Docket Number:	09-AFC-06C
Project Title:	Blythe Solar Power Project - Compliance
TN #:	201190
Document Title:	Staff Response to Comments on the Staff Assessments Parts A and B
Description:	N/A
Filer:	Tiffani Winter
Organization:	California Energy Commission
Submitter Role:	Commission Staff
Submission Date:	11/13/2013 2:57:24 PM
Docketed Date:	11/13/2013

RESPONSE TO PUBLIC COMMENTS

BLYTHE SOLAR POWER PROJECT RIVERSIDE COUNTY, CA

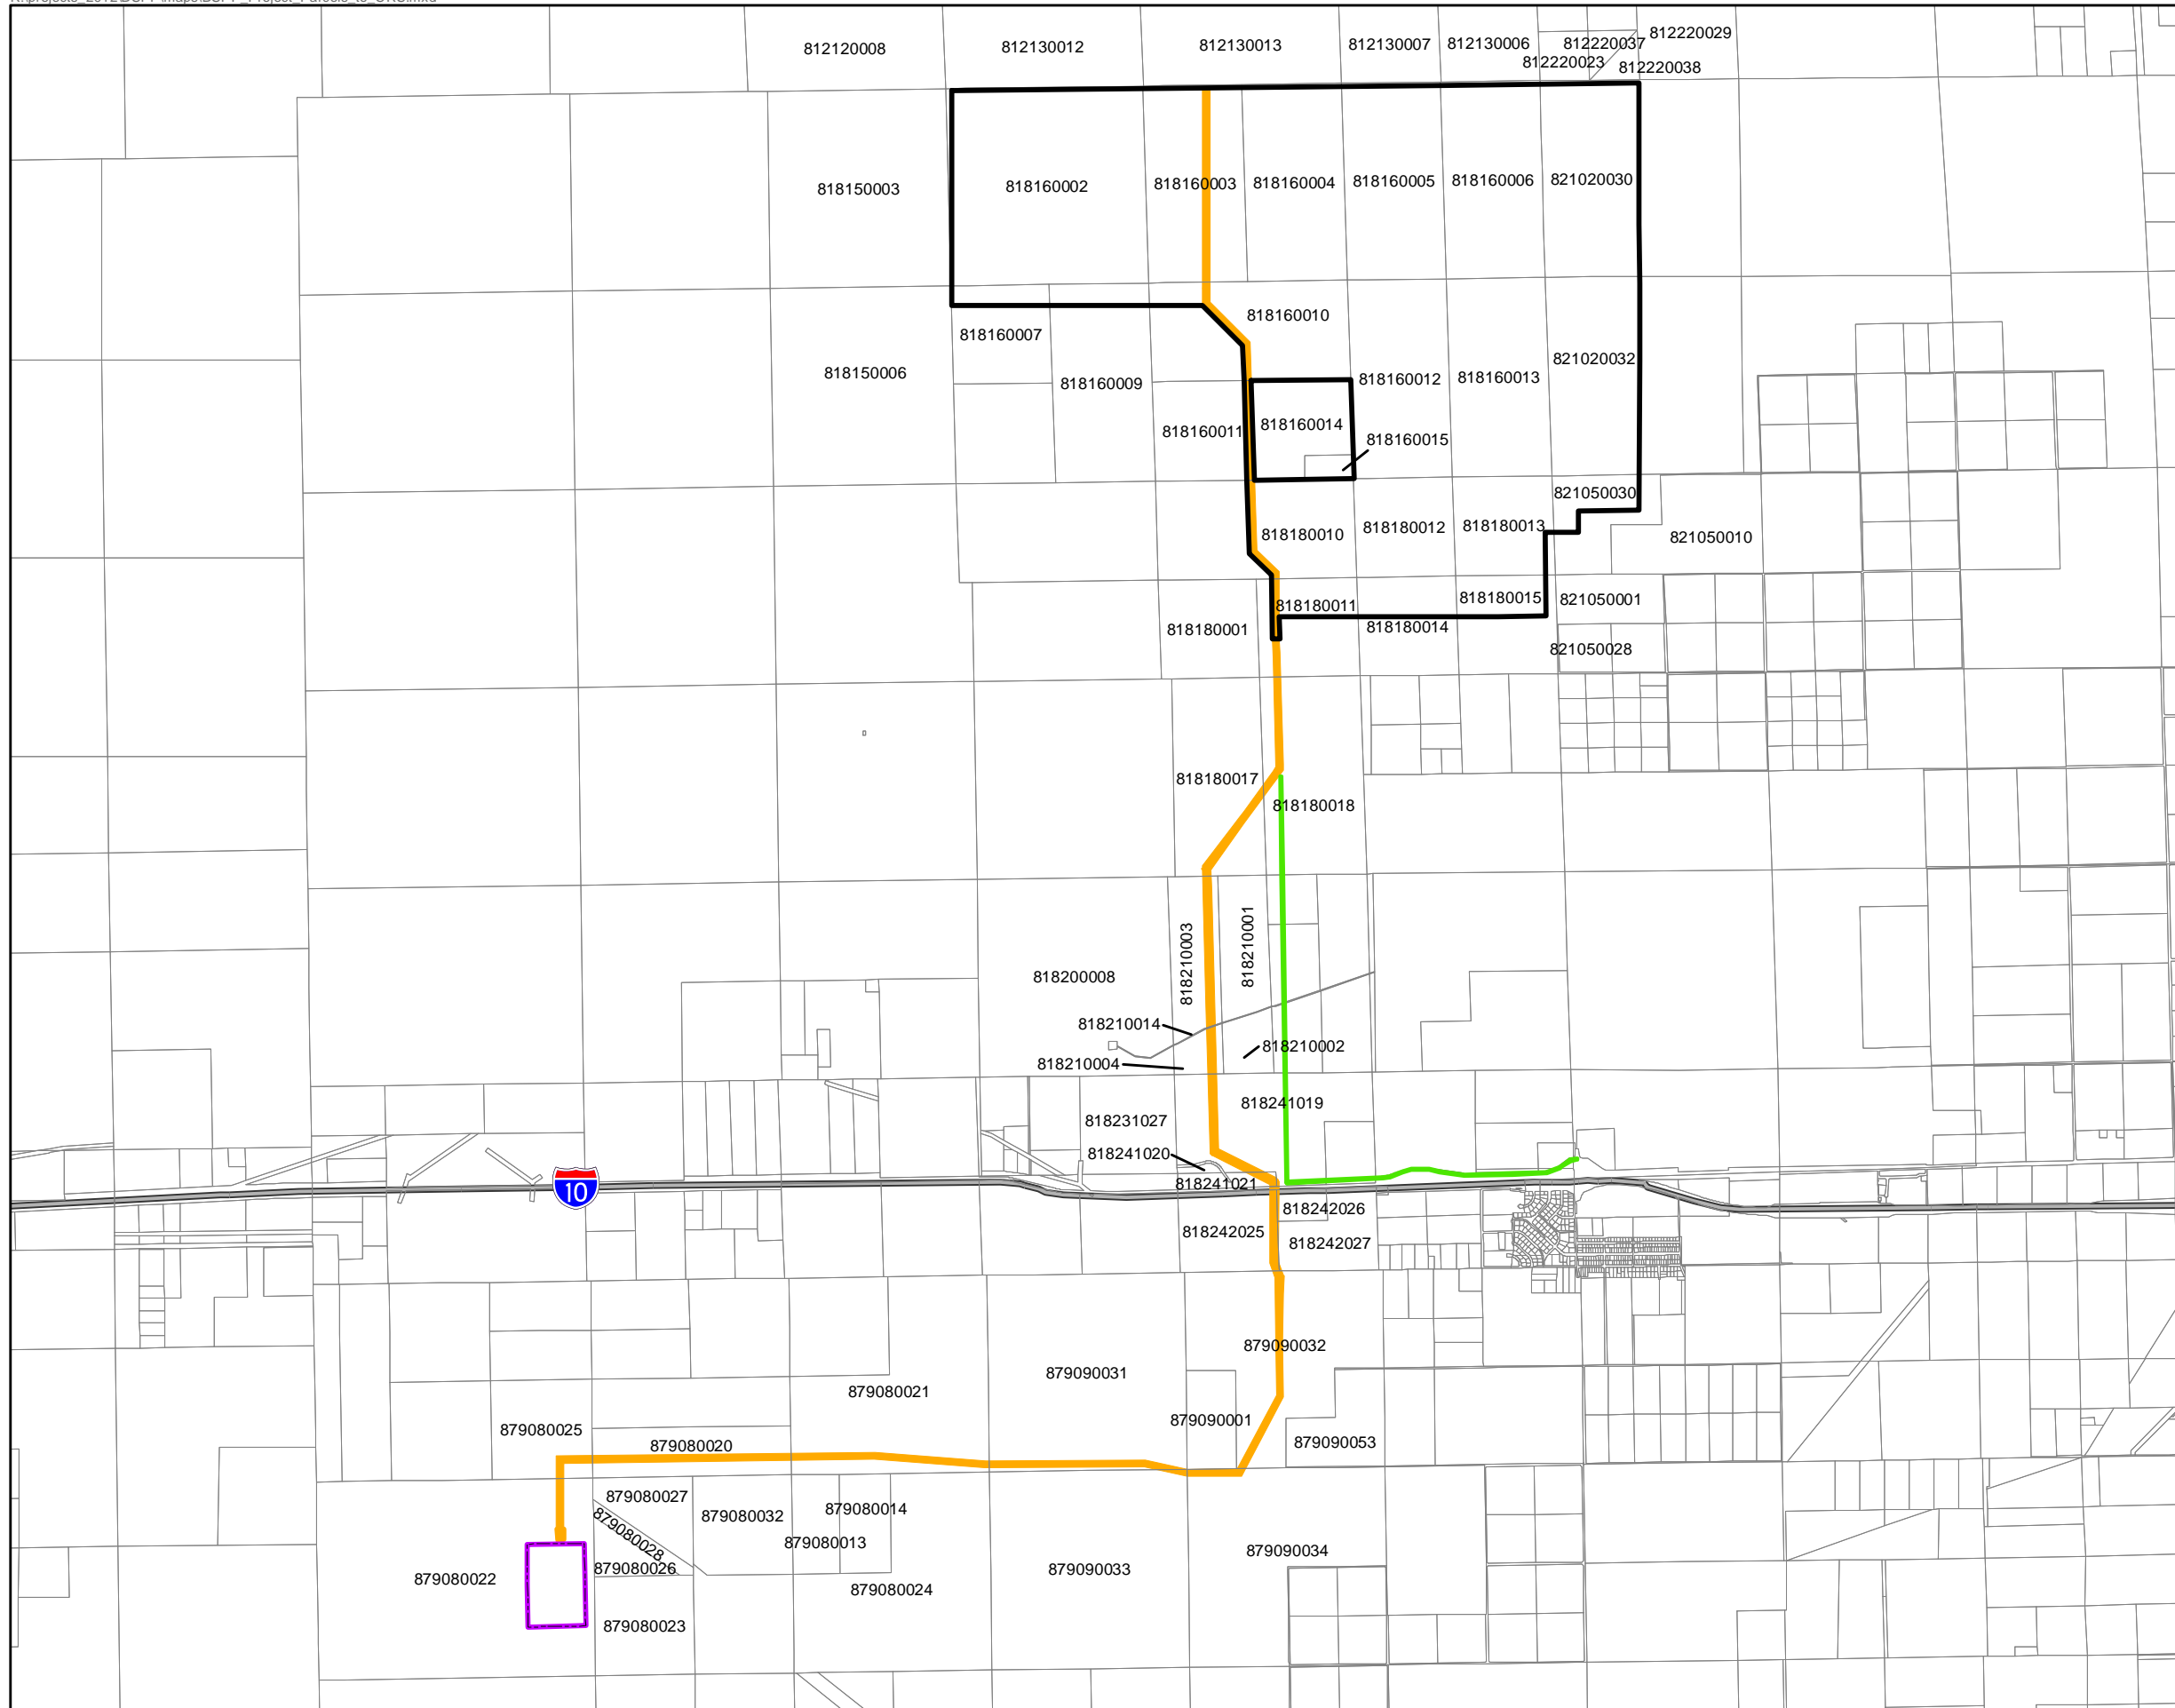
COMMENT: I WOULD LIKE THE EASEMENT BLM GRANTED TO NEXTERA IN A PDF FORM WITH DIMENSIONS AND ALL APN NUMBERS FROM THE FREEWAY TO THE PROJECT (BLM SHOULD HAVE THIS ON FILE) I WOULD ALSO LIKE TO KNOW HOW THEY COULD GRANT THIS EASEMENT WITHOUT CONTACTING PRIVATE PROPERTY OWNERS FOR THEIR INPUT ? I WOULD ALSO LIKE TO RECEIVE THE LATEST SITE PLAN FOR THIS PROJECT WITH PROPOSED FENCING, RIGHT OF WAY BOUNDARY AND BUFFER ZONES. I WOULD ALSO LIKE TO RECEIVE INGRESS EGRESS EASEMENT WITH ALL DIMENSIONS AND APN FROM THE FREEWAY TO THE PROJECT.

RESPONSE: Staff is not clear as to what easement is being referenced. The BLM will issue a Right of Way to the project applicant for the use of BLM managed land. The attached map provides parcel numbers and the boundary line for the proposed project. Staff understands Mr. Porter's parcel is #818180001 which is located outside the project boundaries. Additional maps showing various project features can be found in the Revised Petition to Amend, available on the Blythe project page on the Energy Commission's website, at the following pages: 2-3, 2-4, 2-23 and 5.1-6. In addition, Appendix B-1 to B-5 of the Revised Petition to Amend contains the Right of Way legal description and maps of all the project features including the solar field, transmission line and access roads. Staff believes these maps will provide all the information the commenter is looking for and will confirm the project is not on private property. Staff is unaware of any easement over private property that has been granted by the BLM to the project owner. In addition to the maps contained in the Revised Petition to Amend, the BLM posts a project map on its webpage for the project which can be found at: http://www.blm.gov/ca/st/en/fo/palmsprings/Solar_Projects/Blythe_Solar_Power_Project.html
